Shearwater Petrel 2/Perdix/Perdix AI/NERD 2/ Peregrine Firmware v84 Release Notes

เวอร์ชัน 87 2021-11-01

VERSION 84 2021-07-26

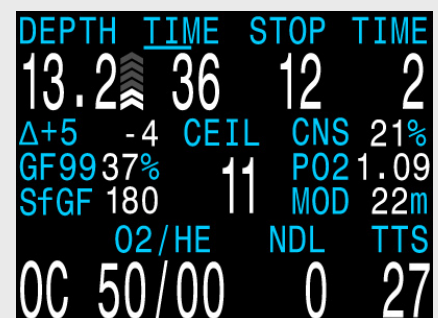
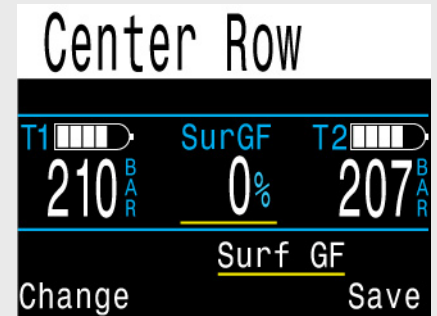
เพิ่มหน้าจอแสดงผลขนาดเล็กที่กำหนดค่าได้ หน้าจอเหล่านี้สามารถแสดงผลได้ถึง 3 ค่าจากแต่เดิมใช้แสดงผลเพียงค่าเดียว แต่ตัวอักษรจะเล็กลง

สามารถกำหนดค่าของหน้าจอแสดงผลขนาดเล็กสองหน้าจอ การกำหนดค่าจะแยกกันระหว่างโหมด Tec (OC Tec, CC/BO) และโหมด Rec (Air, Nitrox, 3 GasNx)

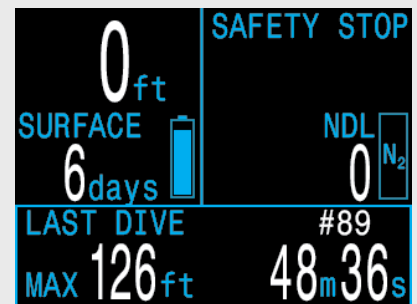
Added user configurable “Alerts”. These can be programmed to provide a warning when specified limit is reached. Also, the applicable display on the main screen will change to yellow while limit is exceeded. On the Peregrine, the vibration will activate with the warning.

The “Vibration” setting is only available on the Peregrine. Other models are visual alerts only.

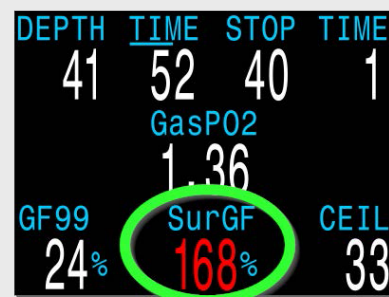
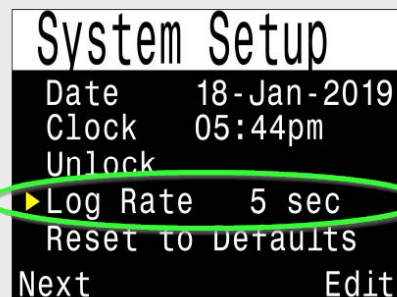
Surface GF display added. This shows the gradient factor if you were to surface immediately. This is different from GF99, which shows your gradient factor at the current depth. Is available:

Log sampling rate can be set to 2, 5, or 10 seconds (previously always 10 seconds). Note that log downloads may take longer with faster sampling rates as more data is being recorded. Also, less logs can be stored until they are overwritten. For example, about 1000 hours are stored at a 10 second rate, but only 200 hours at a 2 second rate.

New OC Rec Deco Options

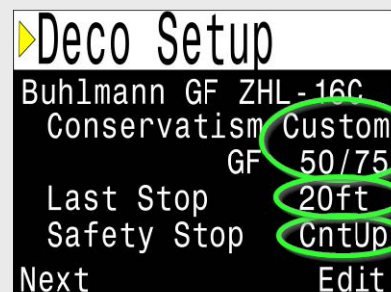
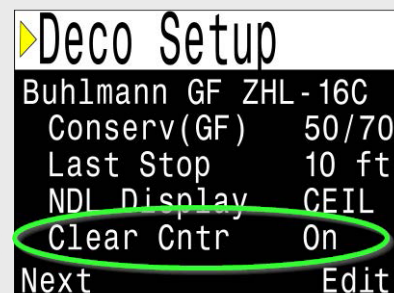
Allows user to select a 20ft/6m last stop depth in OC Rec mode. Previously the last stop was always 10ft/3m in OC Rec mode.

A “Deco Clear” up-counter option has been added.

When deco clears this counter begins counting up from 0. It is useful for timing additional padding after the mandatory decompression stops. If the dive did not need deco, then begins upon entering the safety stop zone (i.e. shallower than 20ft / 6m).

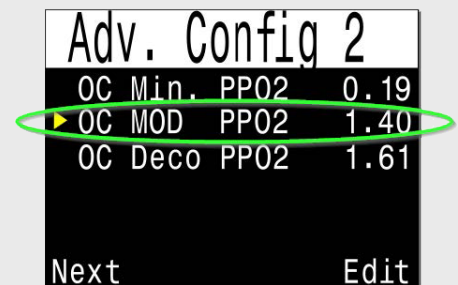
Previously, there was an “OC Max PPO2” setting which only defined when the “High PPO2” message occurred, regardless of dive phase (e.g. bottom depth or at deco stop). This confused many users who, quite reasonably, assumed it was the “bottom depth” limit and set it to 1.40. This would result in warnings during deco when the PPO2 was pushed to the 1.60 range.

The “OC Max PPO2” has now been removed and replaced with a “OC MOD PPO2” setting. The MOD setting only applies to the bottom depth phase. The dive computer automatically switches to using the “OC Deco PPO2” limit when within 2 stops of the next deco stop. The “OC Deco PPO2” limit also sets where predictive deco gas switches occur. Also, if the current gas has greater than or equal to 80% oxygen fraction, then the deco limit is used, as the gas is assumed to be a deco gas.

The “OC MOD PPO2” replaces “OC Max PPO2” with different behaviour. Please read the description to left!

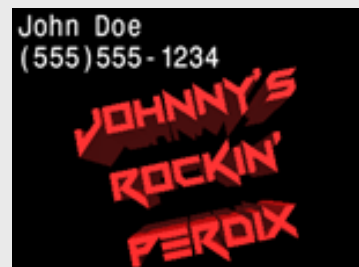
CHANGE The 'OC/CC' mode has been renamed to 'CC/BO', where BO means bailout.

Purpose is to clarify that OC/CC mode was never intended to be used for purely OC dives. Using the OC/CC mode for OC dives results in sub-optimal operation. This change clarifies the CC/BO mode is for closed circuit dives, with open circuit bailout.

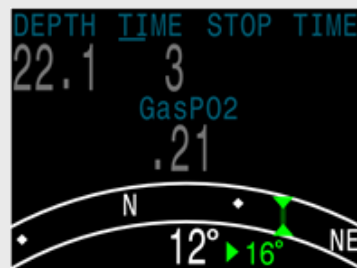
CHANGE Compass mark heading menu moved to reduce button presses. Also, the compass can now be viewed while marking. Operation: when viewing compass a left button press brings up an "Exit/Mark" menu. Right press marks compass, Left press exits to main screen. Previously had to navigate to regular menus to mark the compass.

The mark heading command now requires less button presses

IMPROVE When a heading is marked, the display now shows the offset angle between the current heading and the marked heading. This is useful for navigating patterns. For example, a box pattern requires turns at 90° intervals, while a triangle pattern requires turns at 120° intervals.

The offset between current and marked heading is now shown (in this example 16°)

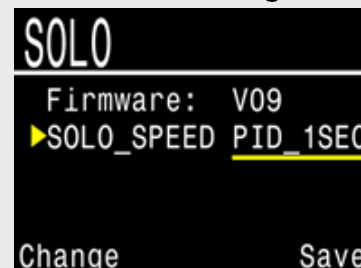
NEW Added support for changing settings on peripheral boards.

For example, on the SOLO board (solenoid and oxygen controller) the Solenoid Speed setting can be adjusted. Go to “Bus Devices” page on Petrel to access peripheral boards. Settings viewed here are stored on the peripheral device.

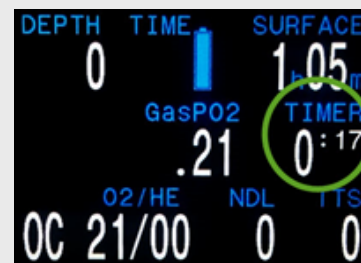
The current compass numerical value (azimuth) is shown on the “Mark Heading” menu.

After marking a heading, if the new mini-compass is shown, returns to the main screen. If mini compass is not shown, returns to the compass screen as before.
